SERVICE BULLETIN

Product : 17" CDT MONITOR

Bulletin No. : 01-C/M-E0028

SUBJECT : DY connector change for 17" model

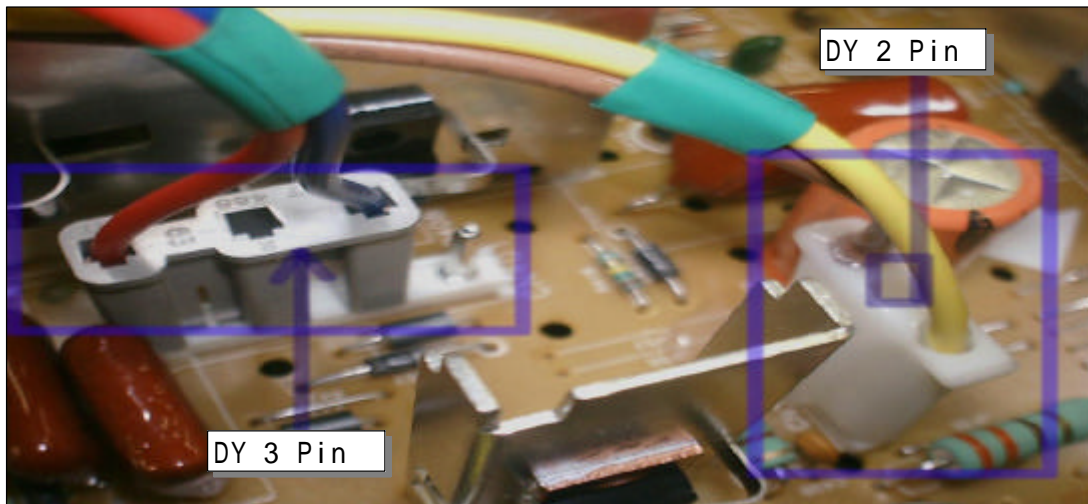
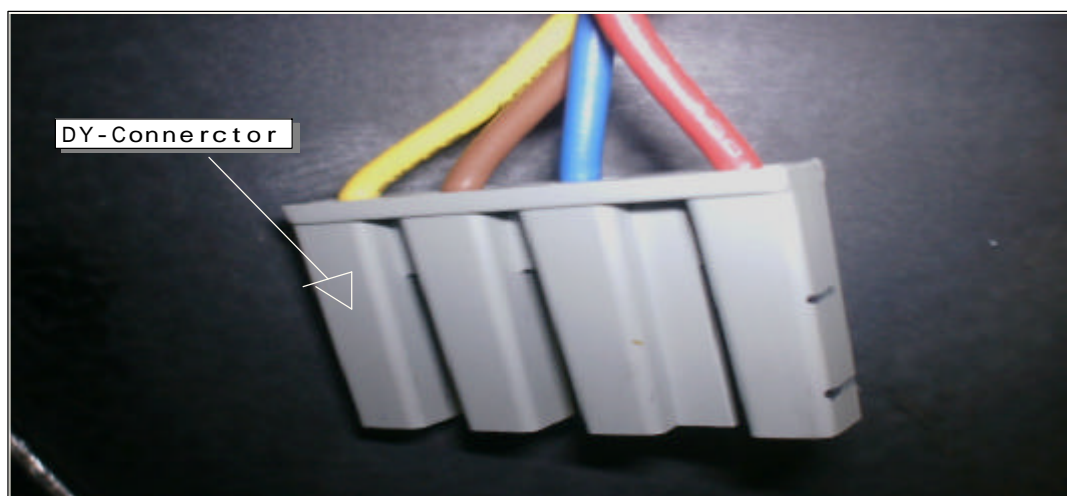
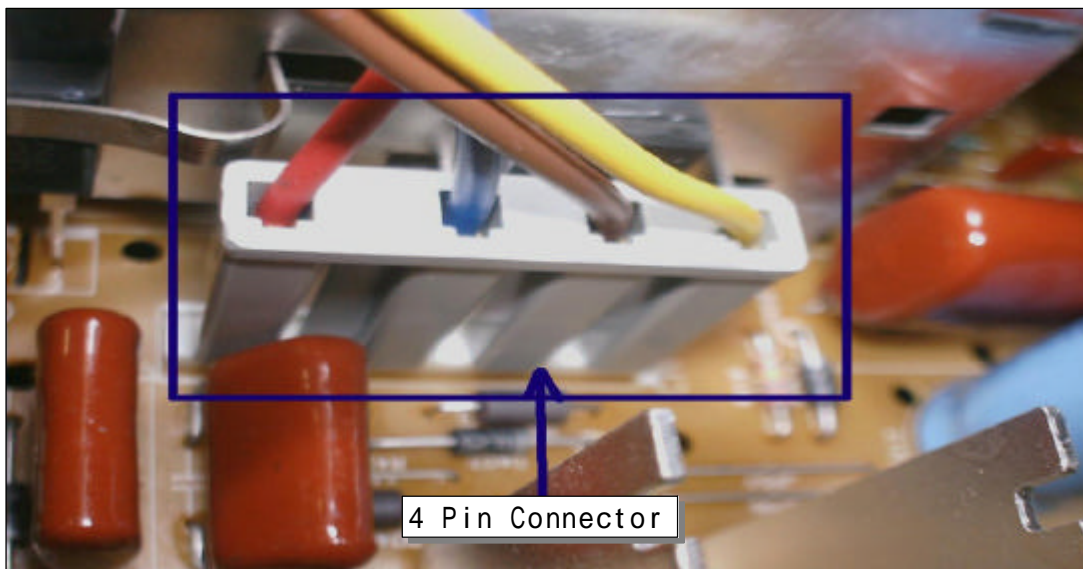
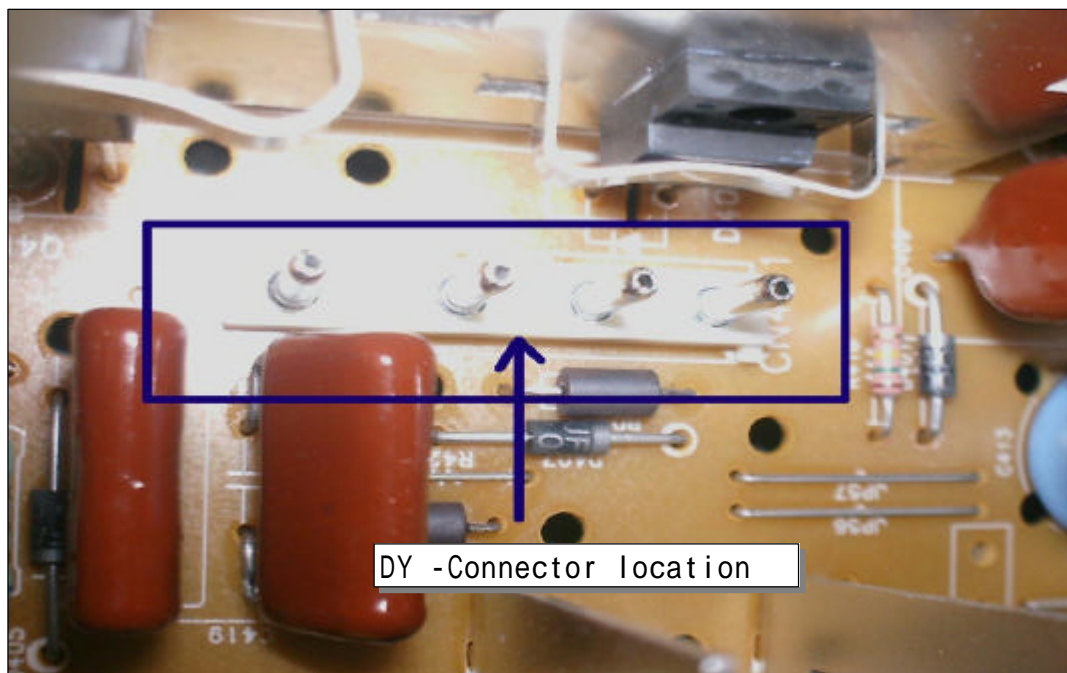
Background : CDT DY connector type have changed (2x3 pin type => 4 pin type)
Please use new CDTs refer to attached information.

Cause : CDT maker changed DY connector type to prevent DY connector loosening

BEFORE : CDT DY CONNECTOR (2x3 pin type)

AFTER : CDT DY CONNECTOR (4 pin type)

Different parts list when changing CDT from 2*3 pin to 4 pin type

Location	Part number	Specification	2x3P CONN.	4P CONN.
JP54	BH39-40305U	CBF-HARNESS, 52MM, AWG22(0.6PI)	O	X
JP56	BH39-40305U	CBF-HARNESS, 52MM, AWG22(0.6PI)	X	O
JP57	BH39-40305U	CBF-HARNESS, 52MM, AWG22(0.6PI)	X	O
CN301	3711-001483	CONNECTOR-HEADER, NOWALL, 3P, 1R	O	X
